**SUBJECT: Comment Response Letter – Bent Grass Residential Filing No. 2 (SF-19-014)**

Please see the following responses in ***bold and italics*** for the 1<sup>st</sup> review of Bent Grass Residential Filing No. 2.

### **Drainage Map**

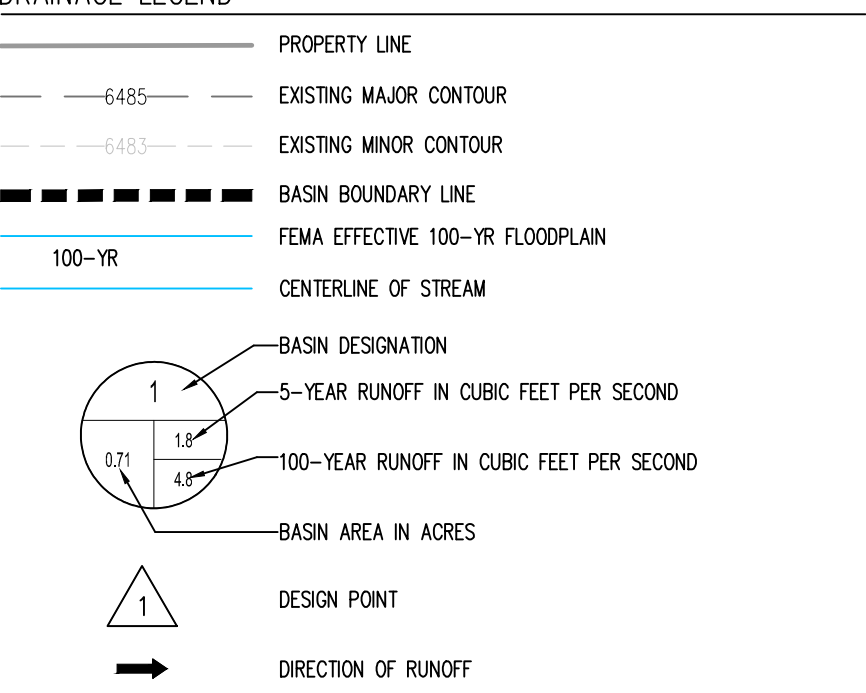
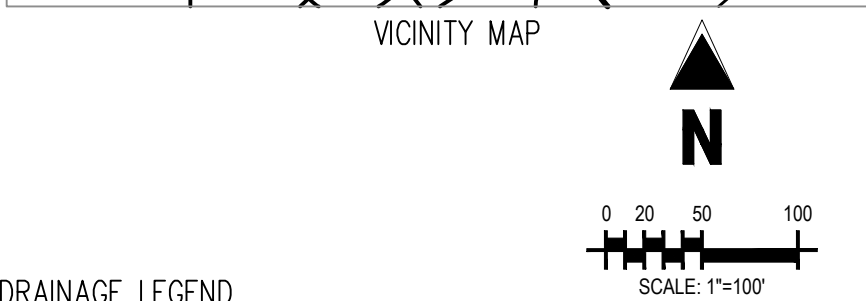
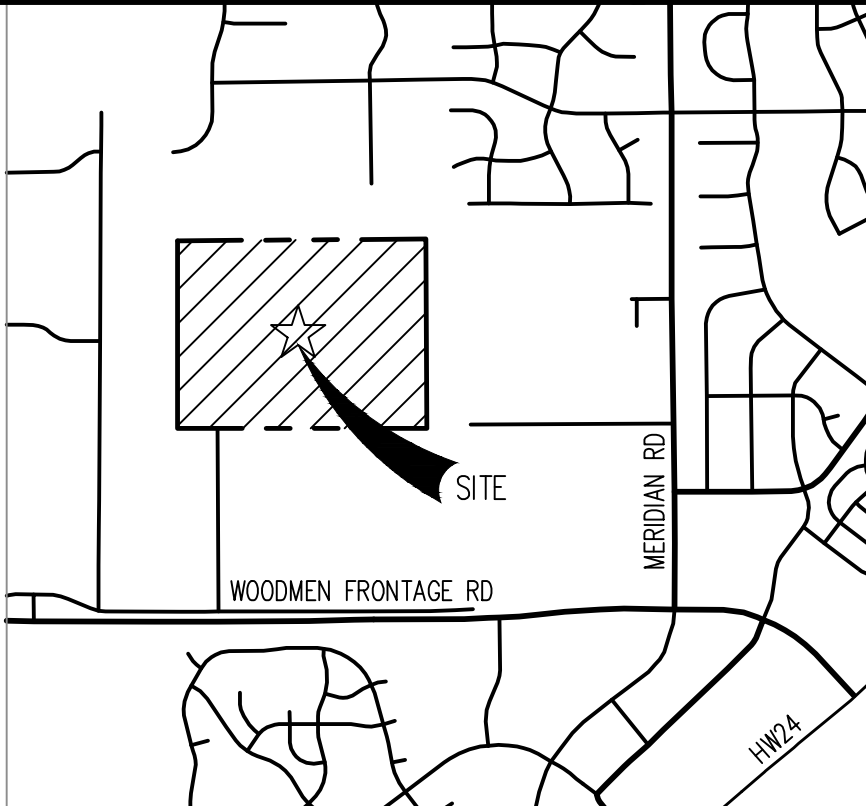
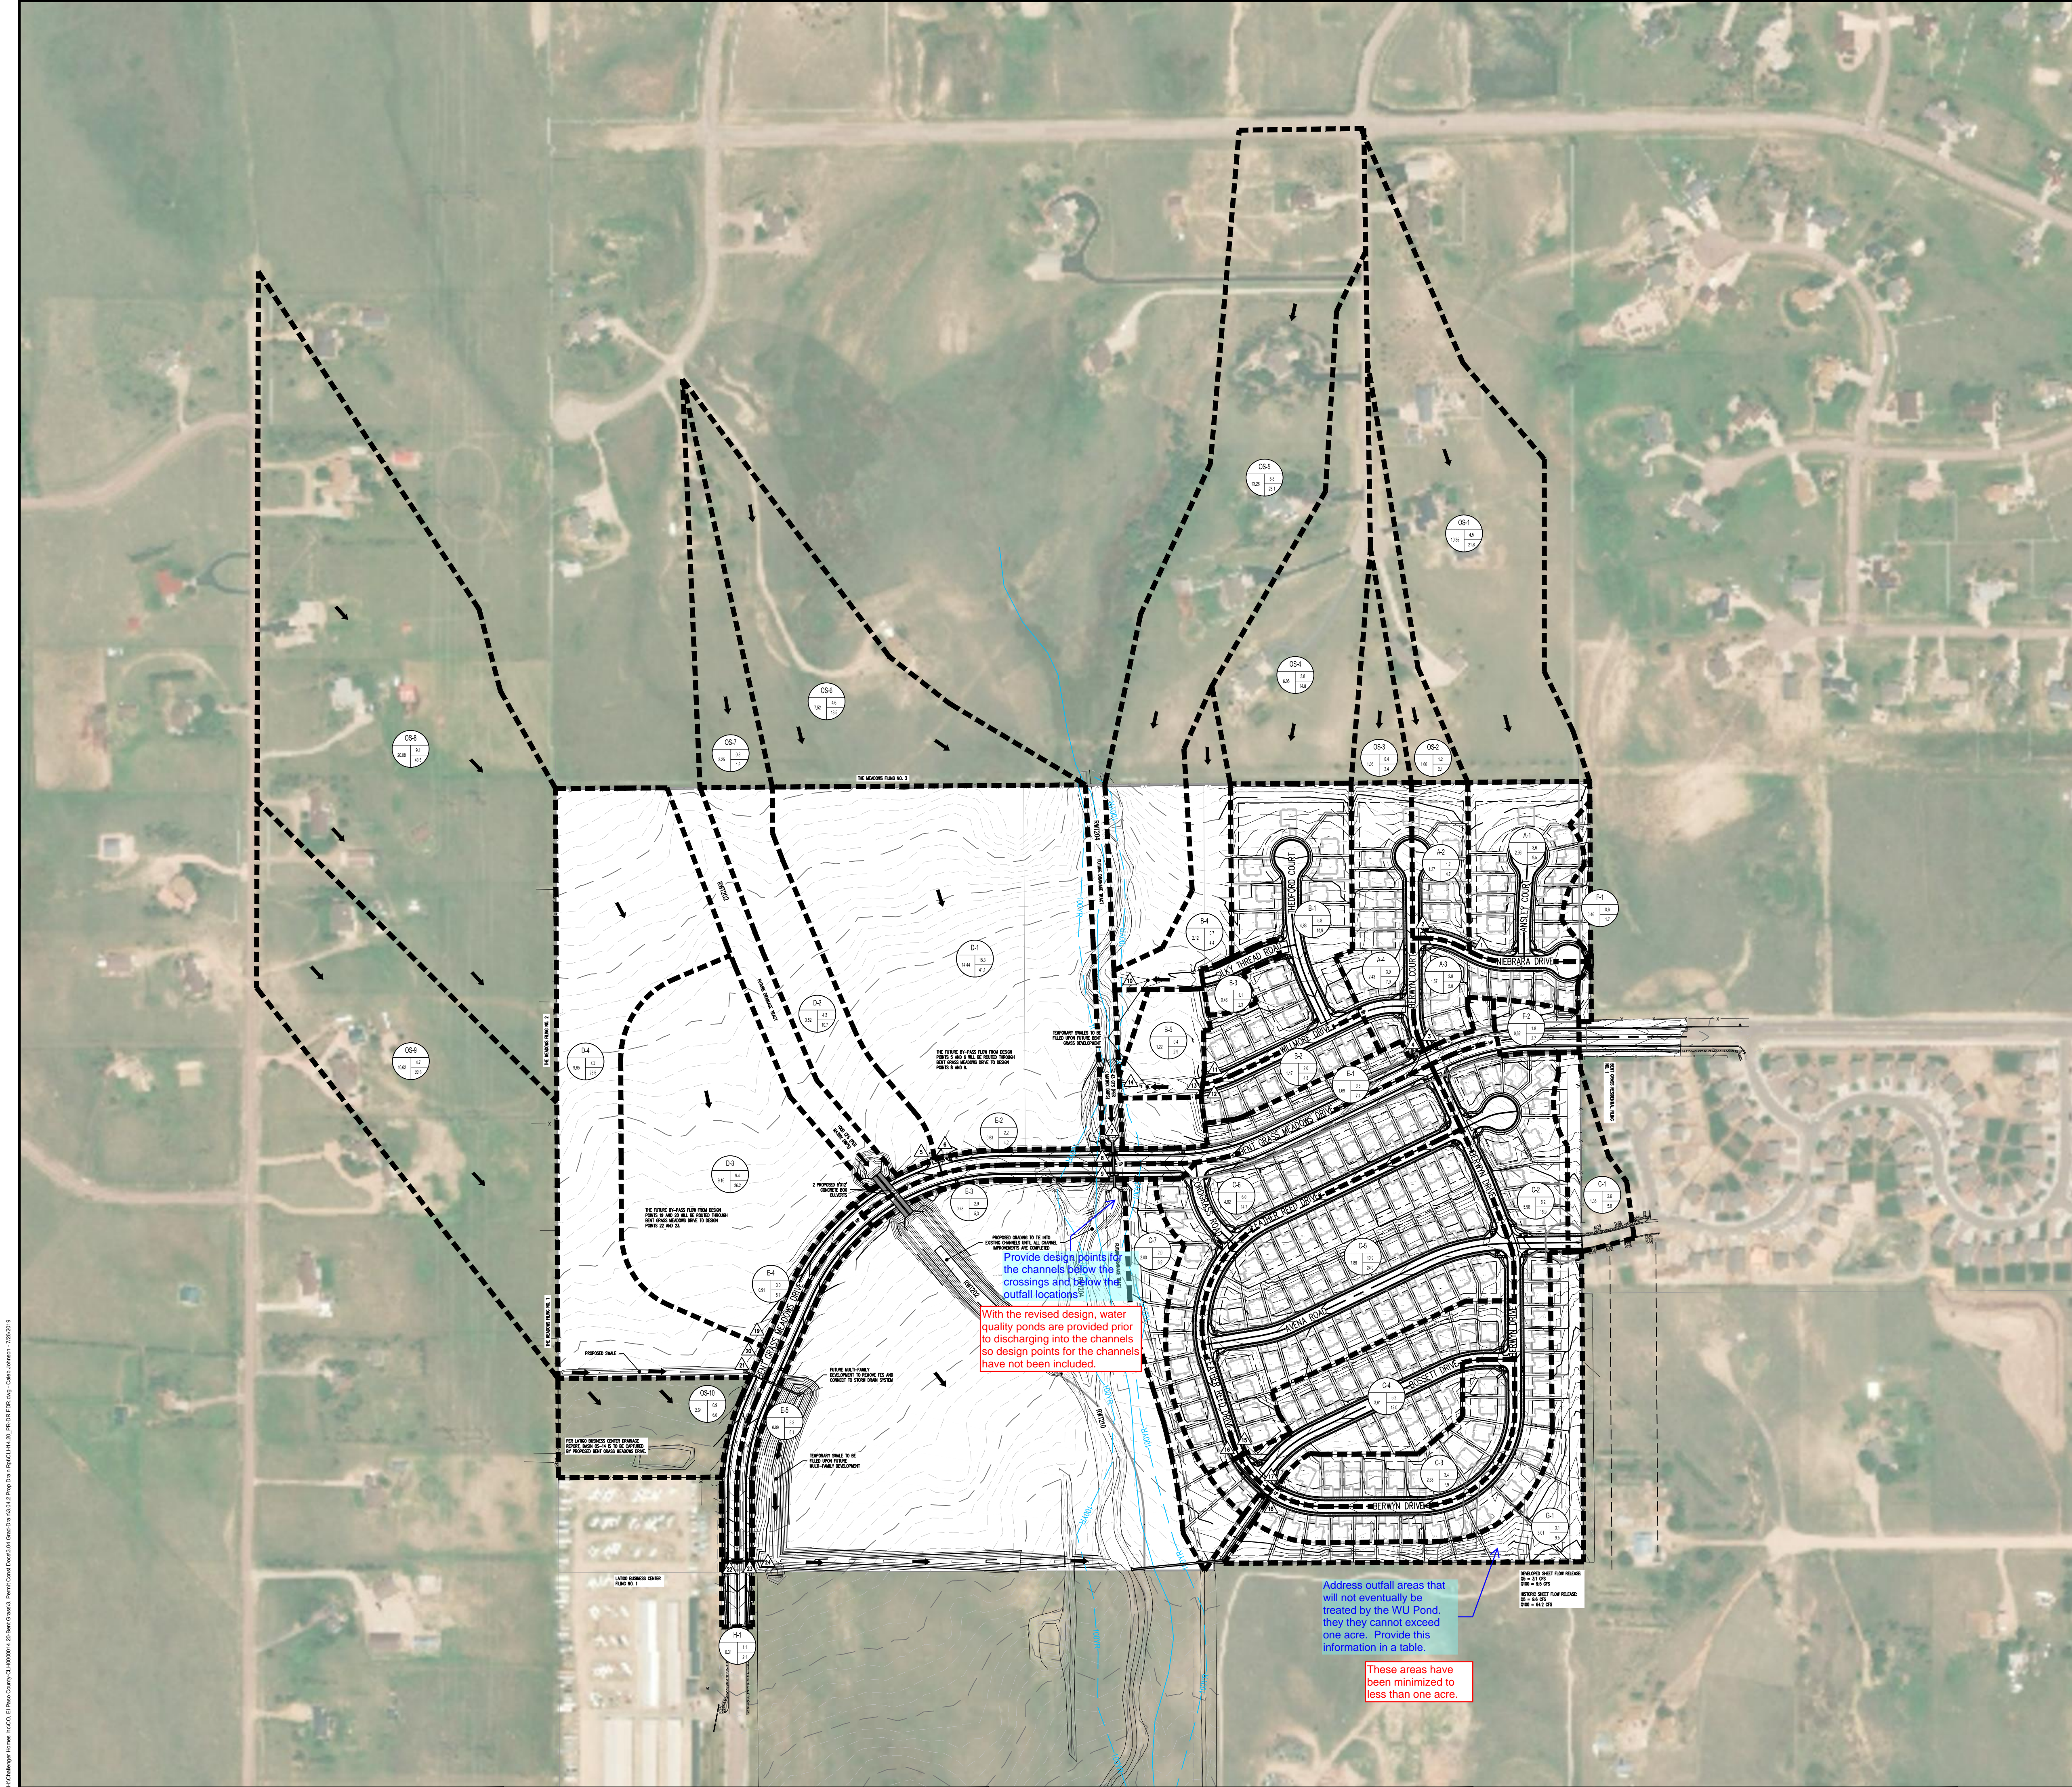
Provide an existing  
conditions drainage  
plan/map.

Existing plan/map,  
calculations, and  
basin descriptions in  
text added.

**BENT GRASS RESIDENTIAL FILING NO. 2 DRAINAGE PLAN**

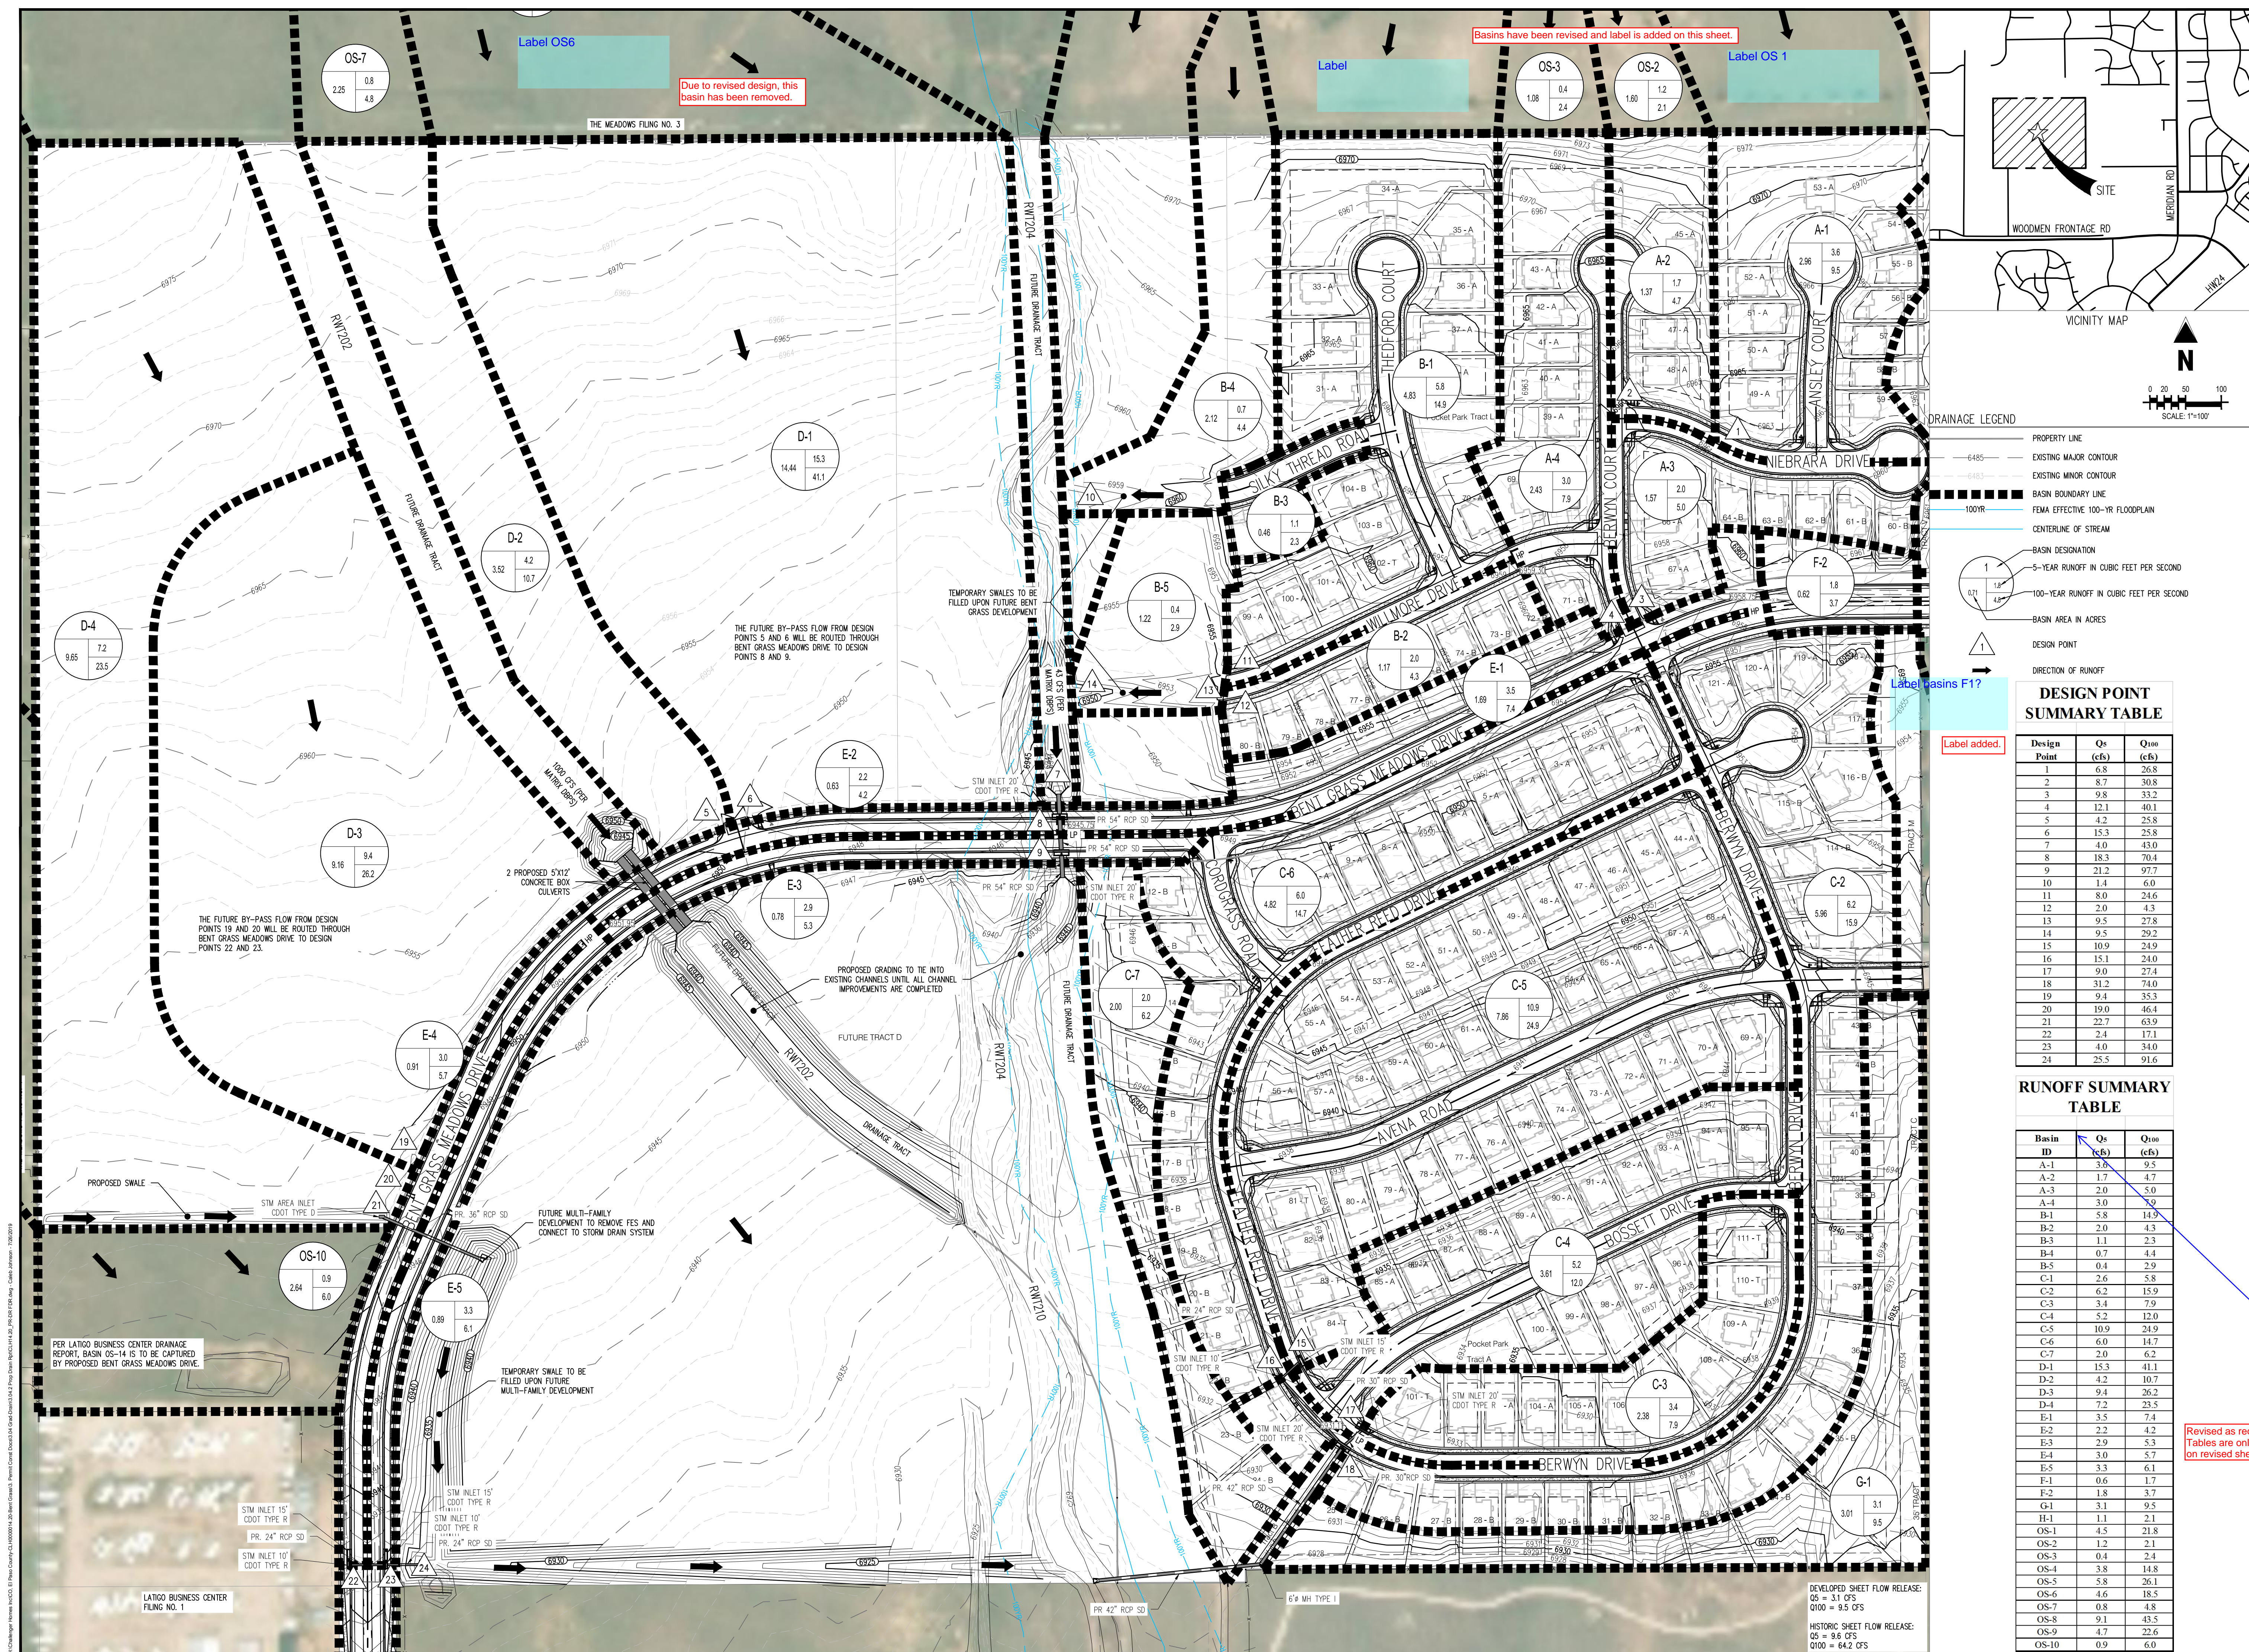
Include acreage of each basin in this table

Summary tables added.
